MODEL	REV	CHANGE LIST	Model	CT3/5 MB BOARD	
			Page	FROM	TO
CT3/5 MB 31CT3MB0015 31CT3MB0031	1A	PAGE 2 --- Enable CLK48M from clock generator for the PLL circuit of 7411, and disable the oscillator circuit of PCI7411 PLL. PAGE 3 --- Remove H/W shutdown circuit that supported ADM1032. PAGE 4 --- Use X7R type to replace Y5V type for CPU Decoupling/Bypass capacitor. PAGE 10 --- Add a terminal resistor R706 for -CODE_RST# to improve signal quality. PAGE 11 --- 1. Add a 10K pull-up resistor on MCH_SYNC# for booting. 2. Change the power plane of PCIE_WAKE# from 3VSUS to 3V_S5 to solve system can't turn off issue. 3. Change the power plane of ICH_THRM# and SCI_# from 3VSUS to +3V to reduce leakage. PAGE 12 --- We can also use 5VSUS to instead of 5V_S5 to save cost of MOSFET(A06402). PAGE 15 --- Add a level-shift circuit for EDID interface. PAGE 17 --- 1. Add a off-page and a EMI solution for CLK48M. 2. Remove the reserve resistors (R693-R695) of parallel interface for PCI1510. PAGE 18 --- Remove R696, connect controller and power switch directly . PAGE 19 --- Change R682&R683 value from 56 ohms to 0 ohm cause of BOM error at A-test. PAGE 22 --- 1. Change MC3 type from Y5V to X7R to improv

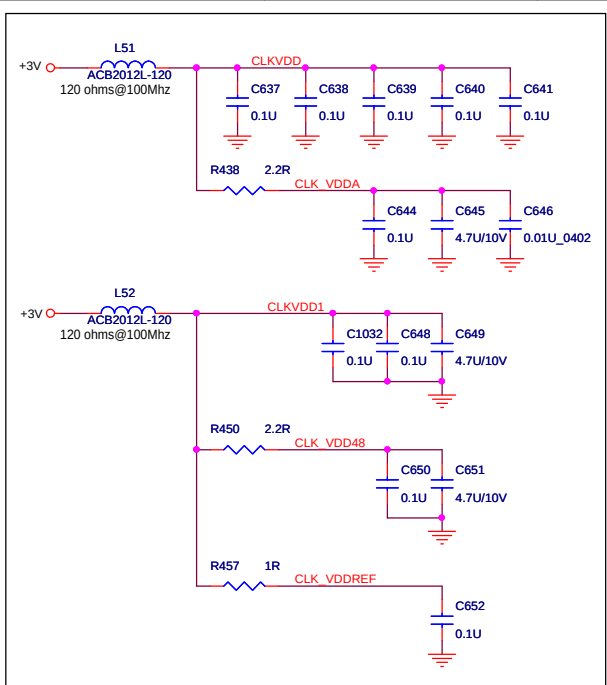
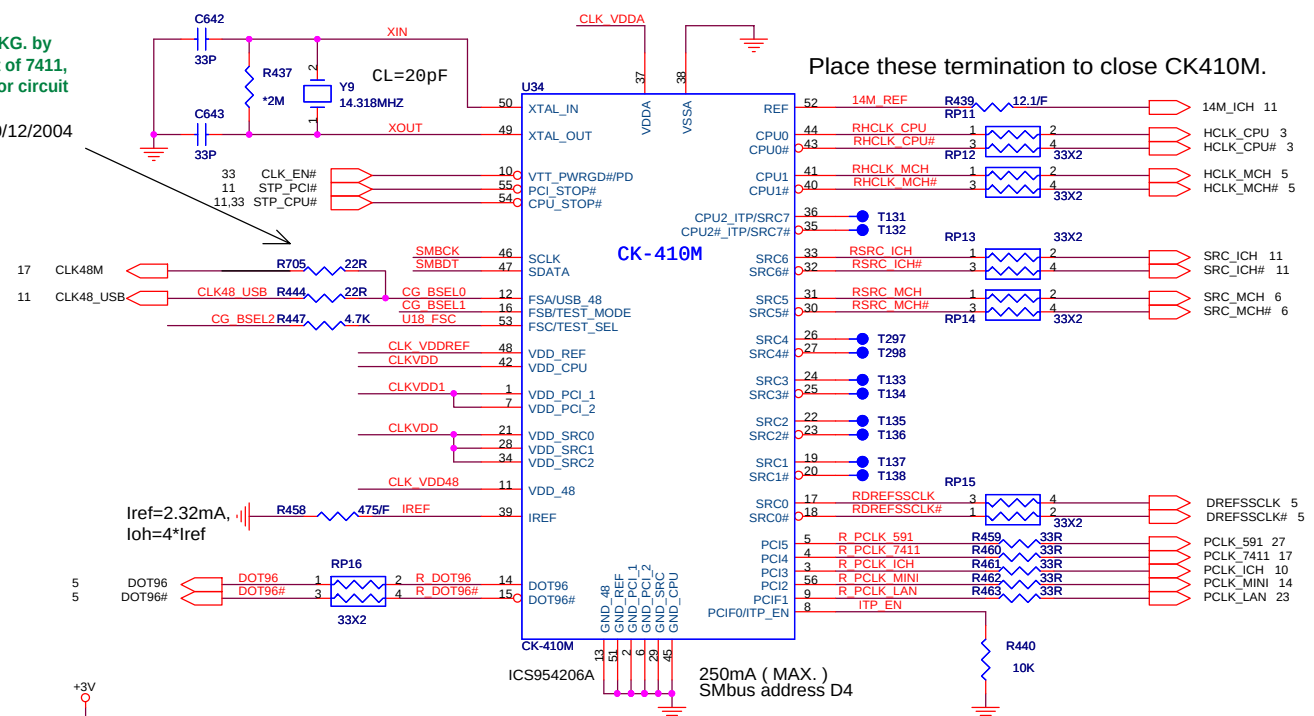
SI stage:
Enable CLK48M from CKG. by
R705 for the PLL circuit of 7411,
and disable the oscillator circuit
at PCI7411 side.

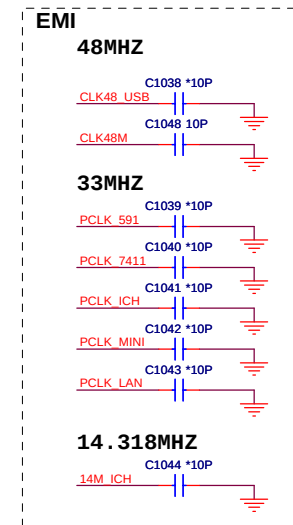
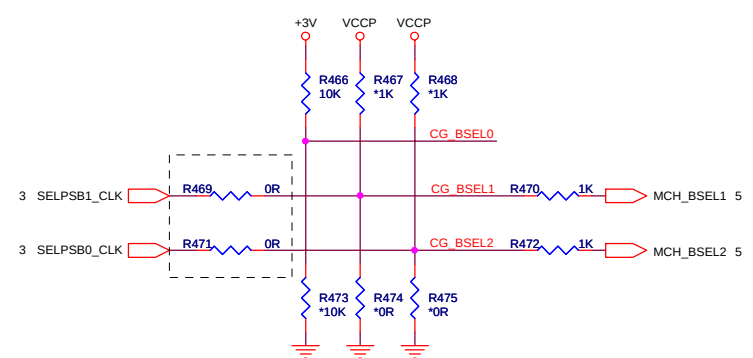
PV stage:
Add C1048 for CLK48M to get better EMI
performance.
Sting 11/29/2004

Size	Document Number	Rev
Custom	CPU POWER / GND	2A
Date:	Monday, December 27, 2004	Sheet 4 of 39

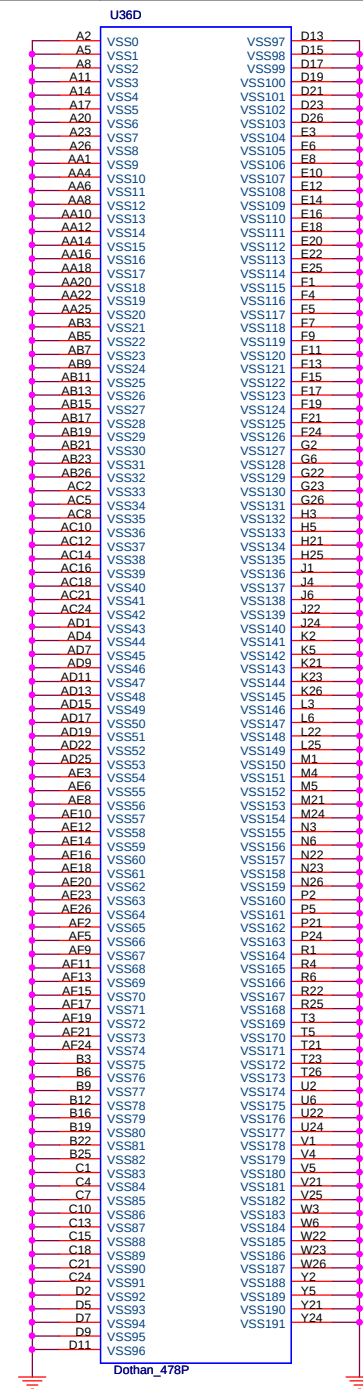
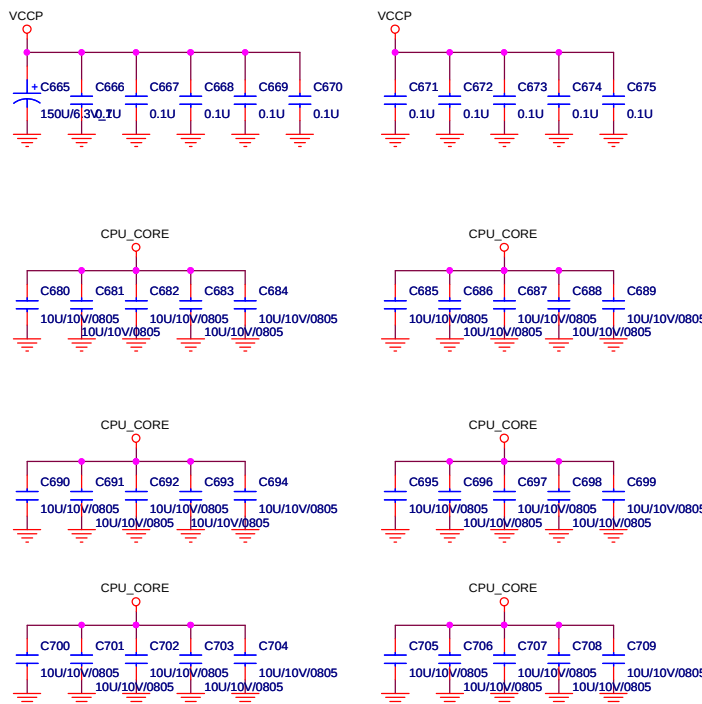
SI stage:
Use X7R type to replace Y5V type
for Decoupling/Bypass capacitor.

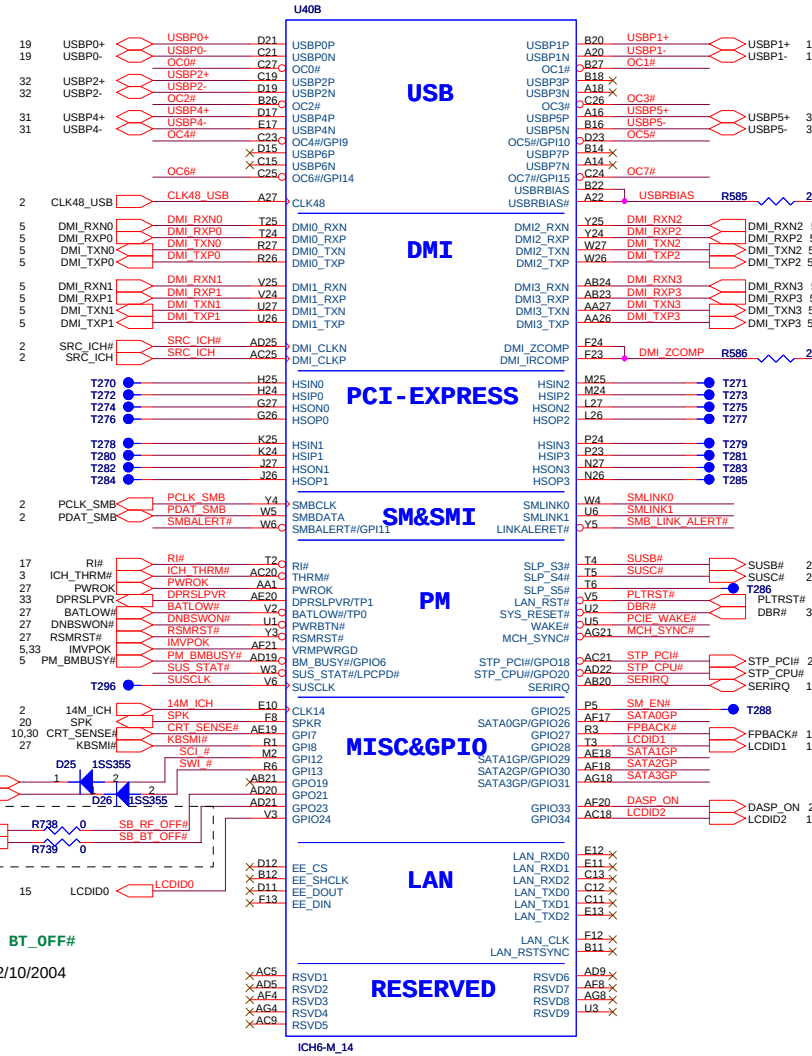
SI stage: Intel suggested us to add a terminal resistor R706 for -CODEC_RST to improve signal quality.

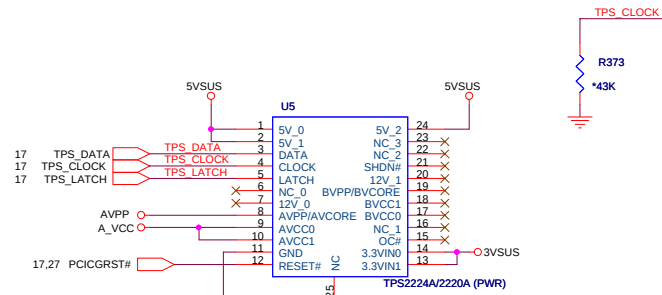
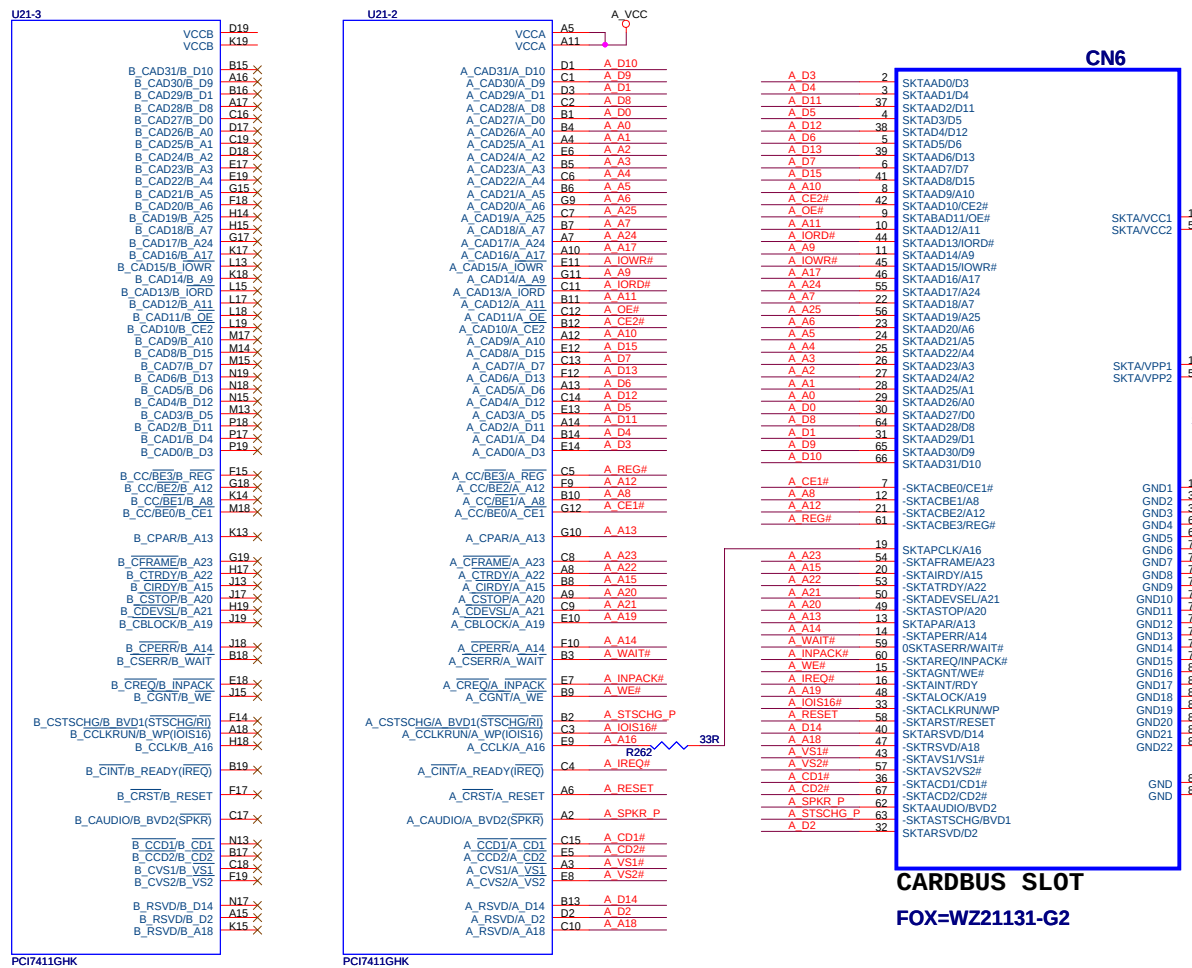
PV stage:
Remove unused PCI1510RVGF circuit.

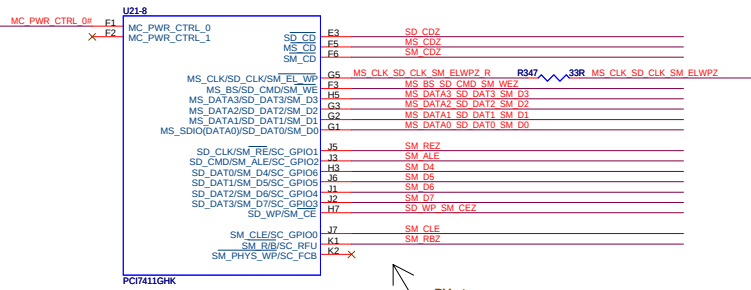
PV stage:
Add a discharge circuit for media
card power.
Sting 11/19/2004

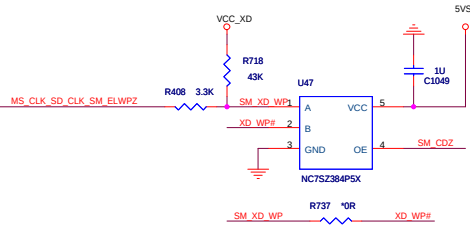
PV stage:
1. Disconnect SM_PHYS_WP.
2. Tie SM_EL_WP with SM_PHYS_WP of SM card to allow
for normal operation of SD and SM.
Sting 11/19/2004

Size	Document Number	Rev
Custom	IEEE 1394A, USBX2	2A
Date:	Monday, December 27, 2004	Sheet 19 of 39

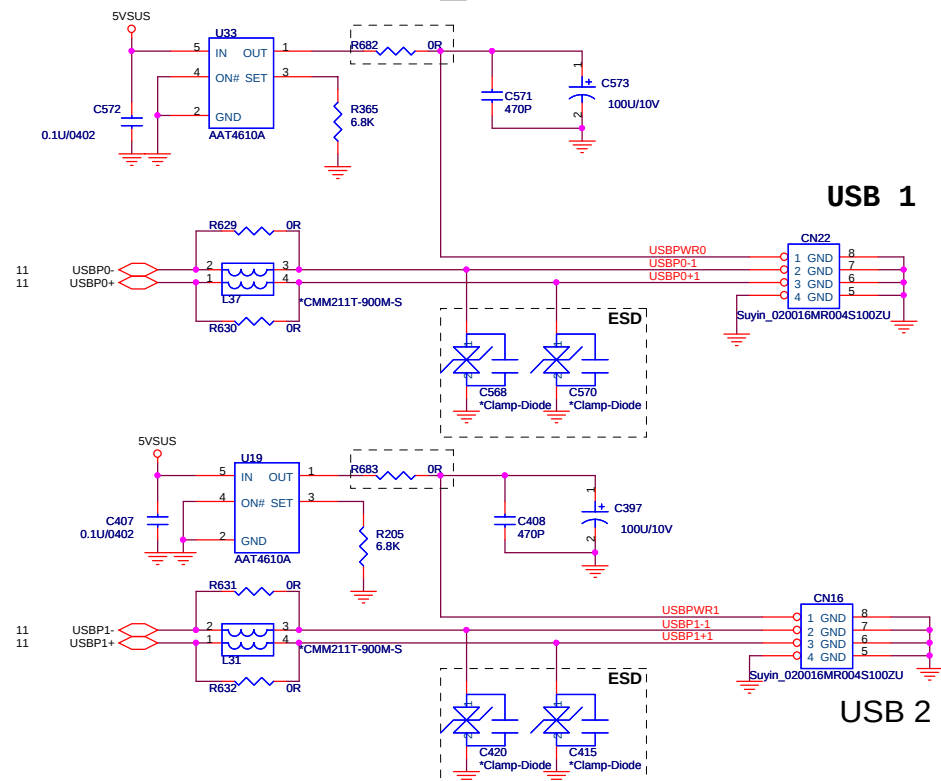
SI stage:
Change R682 and R683 value from 56R to 0R cause of
BOM error in A-test.

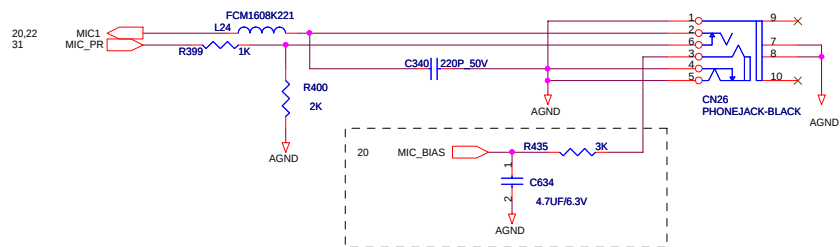
SI stage:
Modified transformer circuit for 10/100M application.

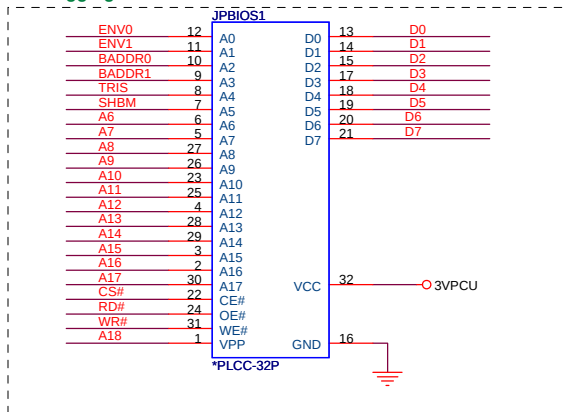
SI stage:
Add PLCC32 cause of it is convenient for Bios debugging.
Sting 10/01/2004

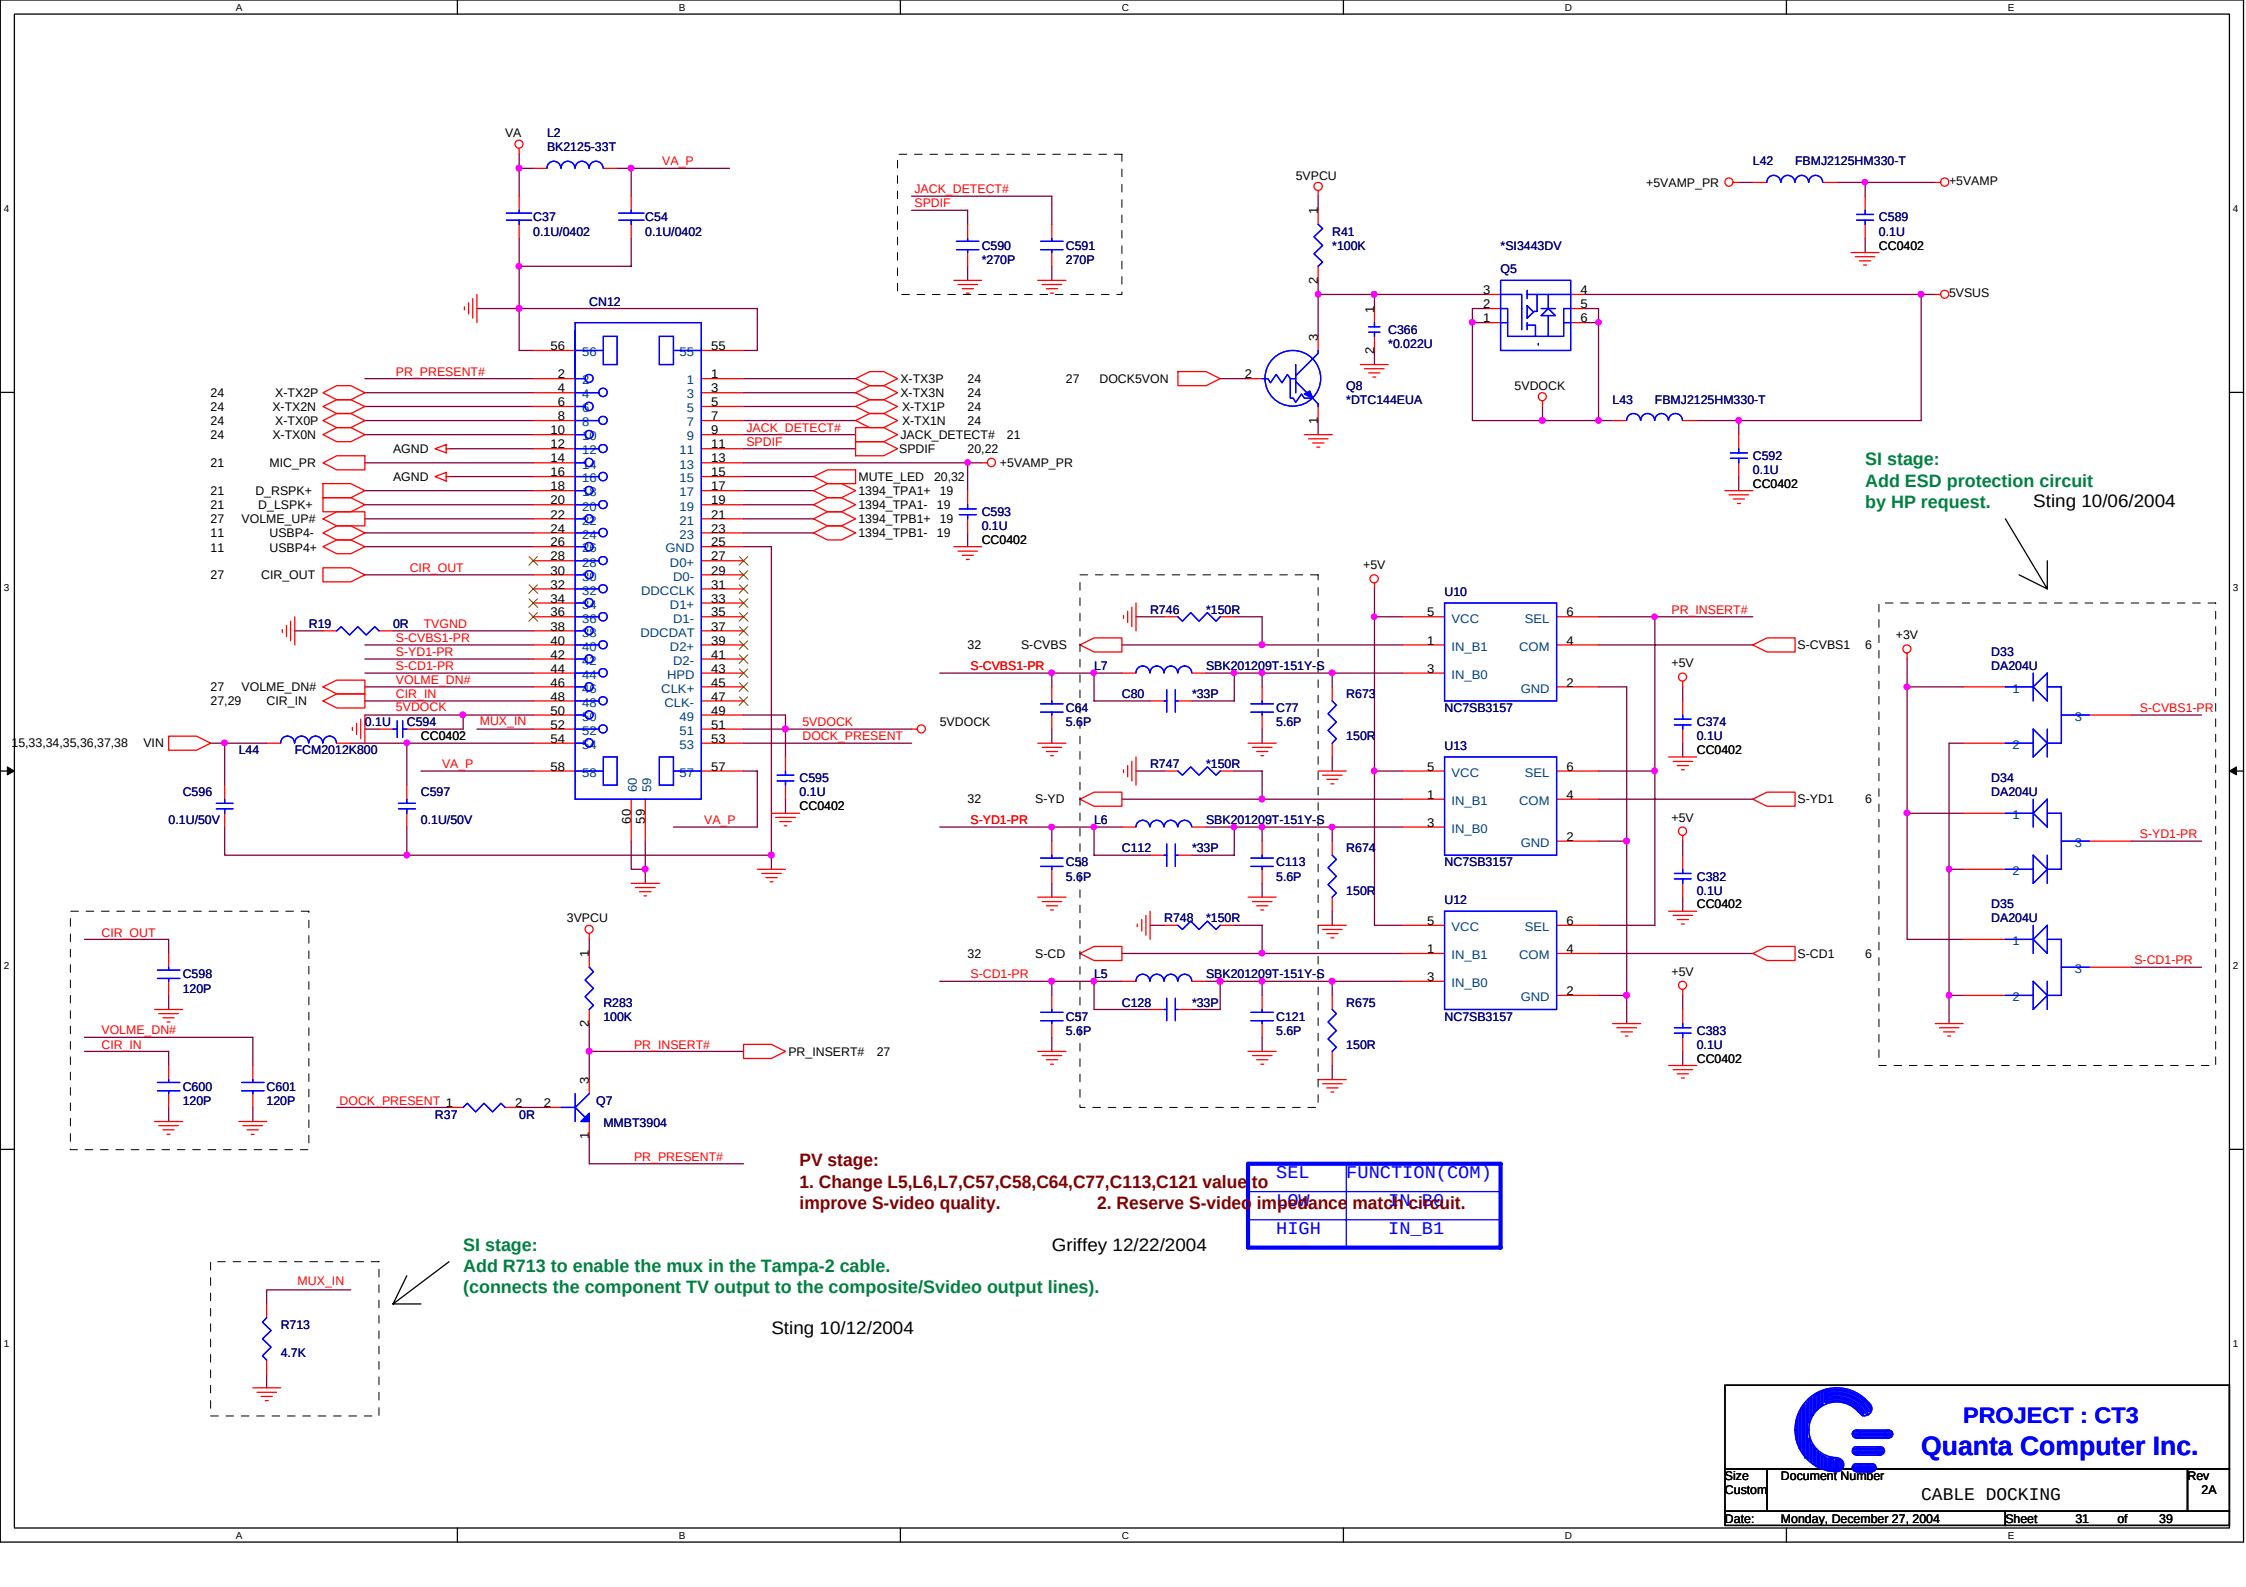
SI stage:
Add ESD protection circuit
by HP request. Sting 10/06/2004

PV stage:
1. Change L5, L6, L7, C57, C58, C64, C77, C113, C121 value to improve S-video quality.
2. Reserve S-video impedance match circuit.

SI stage:
Add R713 to enable the mux in the Tampa-2 cable.
(connects the component TV output to the composite/Svideo output lines).
